**Report: TAB Report**  
**Function: Test, Adjust, & Balance**  
**Date: 01/22/2026**  
**Completed By: National TAB**

**PROJECT**  
**02-02-26 QT #1044 KANNAPOLIS, NC**

QUIKTRIP  
4705 SOUTH 129TH EAST AVENUE  
TULSA, OK 74134

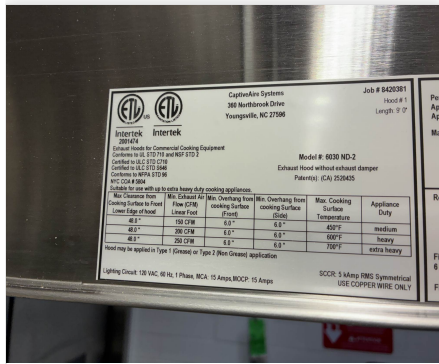
**Issue Name :** EF-2 Excessive Flow  
**Description :** EF-2 is exhausting 161 CFM more air than it should. The speed controller on the fan does not adjust the speed.  
**Created By :** National TAB                      **Assigned To :** National TAB - Dan Hertenstein  
**Status :** Open  
**Priority :** Medium                                      **Asset Tag :** EF2  
**Originated Date :** 02/05/2026 - Alex Bauer - National TAB
